GAME - Team UPDATE - 2012-03-27

GAME - Team UPDATE - 2012-03-13

Week 1 Observations and Reactions

Figure 4-8

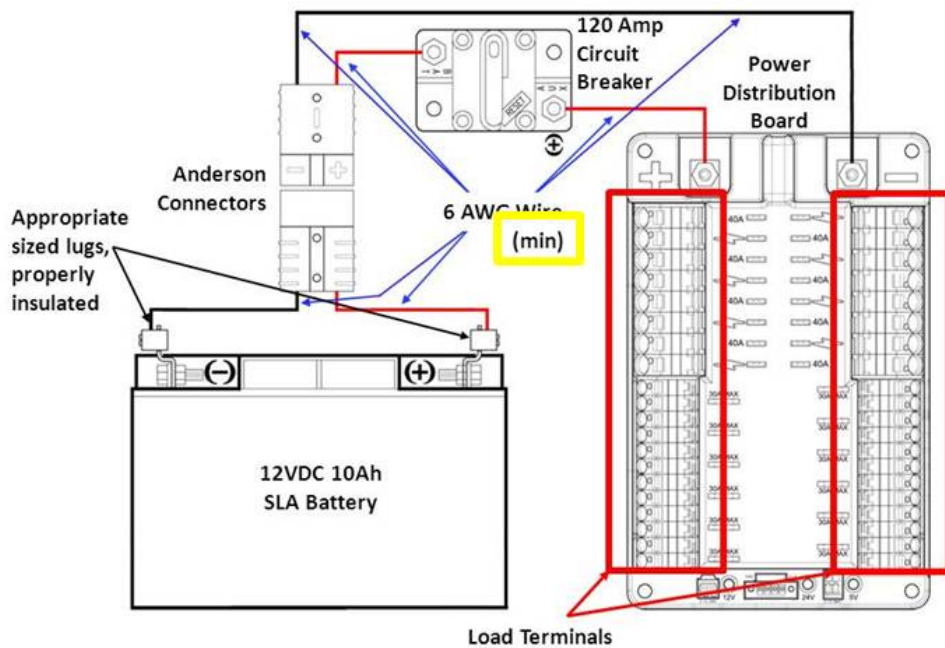
Figure 4-8 was revised to allow wire larger than 6AWG between the battery terminals and the Power Distribution Board terminals.

Figure 4-3

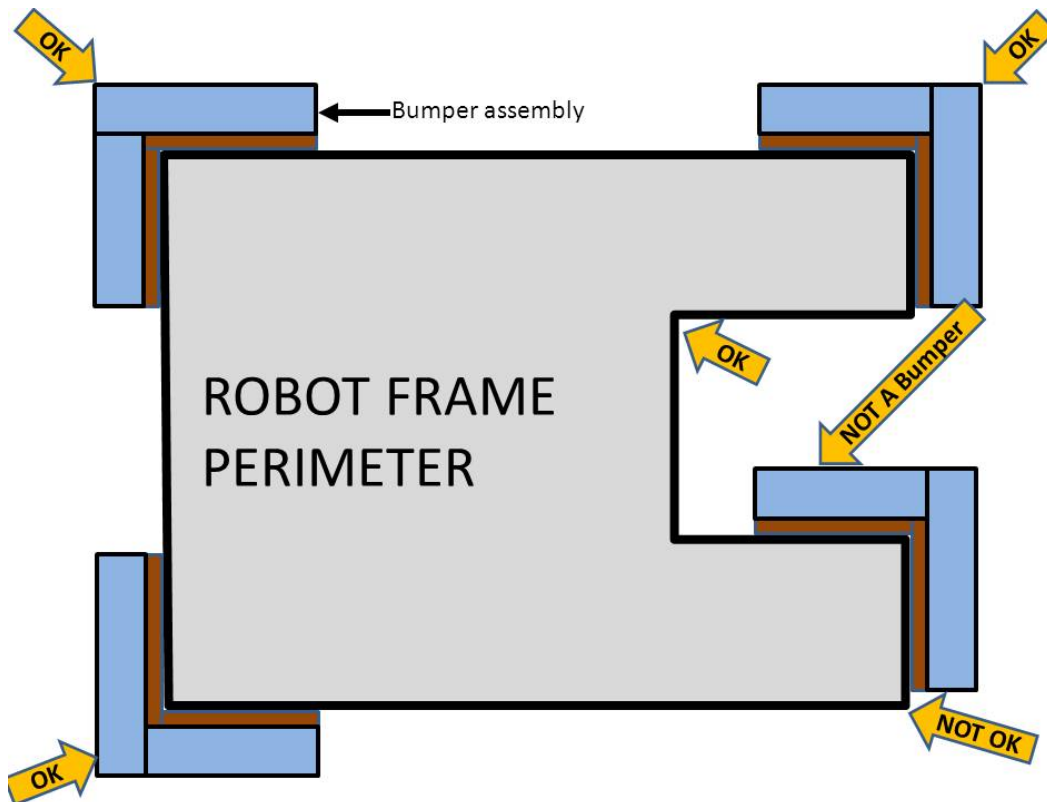
Figure 4-3 has been revised to clarify that example padding is legal, but not considered an official Bumper based on its placement.
